# UNITED STATES PATENT AND TRADEMARK OFFICE

APPLICATION NO.	FILING DATE	FIRST NAMED INVENTOR	ATTORNEY DOCKET NO.	CONFIRMATION NO.
10/565,690	01/24/2006	Claude Baudrenghien	1717214	2525

## Office Action Summary

## **DETAILED ACTION**

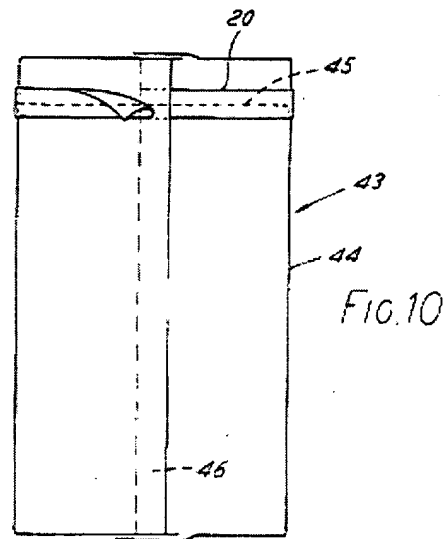
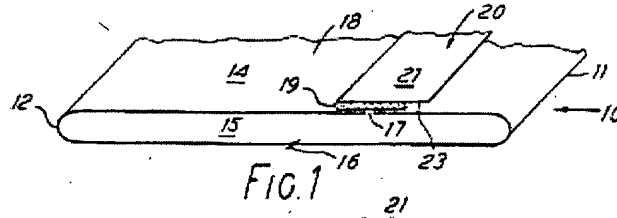
The phrase “**wherein the wall (2) of the envelope (3) extends beyond (4) the second lip (23) of the slot (5), for a distance at least equal to a length of the second zone (14) of the self adhesive strip (10)**” in claim 2, lines 1-2 is vague and indefinite since it is unclear what is the relationship between wall (2) and beyond (4). Furthermore, it is unclear how wall (2) can be equal to second zone (14) when second zone (14) continues to zone #12, as illustrated in FIG-2.

***Fig. 1***

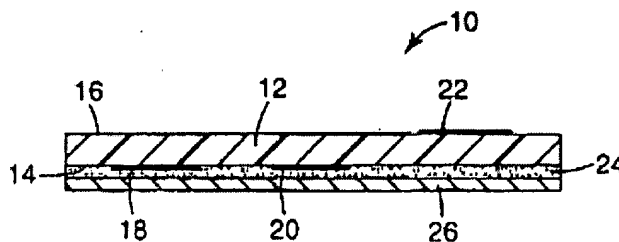
Regarding claims 1-2, Sanders ('399) teaches a sealable package comprising a flexible air impervious envelope (*FIG-1, #10 and col. 2, ll. 5-10*), having outer wall portions of the wall forming slot through the wall and also forming first and second lips adjacent the slot (*FIG-1, portions of wall forming slot with lips on each side of #17*) and an adhesive strip positioned separately to close the slot in the envelope wall (*FIG-1, tape #20 with adhesive #19*), wherein the adhesive strip comprises two parallel adhesive faces (*FIG-1, top and bottom of #19*), wherein a first of the faces is completely covered with a first detachable protective strip (*FIG-1, strip #21*), and wherein a second of the faces comprises a first zone that is fixed to the wall of the envelope (*FIG-1, bottom side of #19 fixed to #14*), along a first lip of the slot and a second zone that

Regarding claim 3, Sanders ('399) teaches a package wherein a length of the above mentioned second zone of the self adhesive strip is at least equal to a length of the first zone of the adhesive strip (*FIG-1, wherein the length of #19 is the same length on both sides of #17*).

Regarding claims 4 and 11-12, Sanders ('399) teaches a package wherein the slot is rectilinear (*FIG-1, rectilinear slot #17*).

Regarding claim 5, Sanders ('399) teaches a package wherein the slot is arranged close to a rectilinear edge of the envelope (*FIG-1, #17 at edge of #14*).
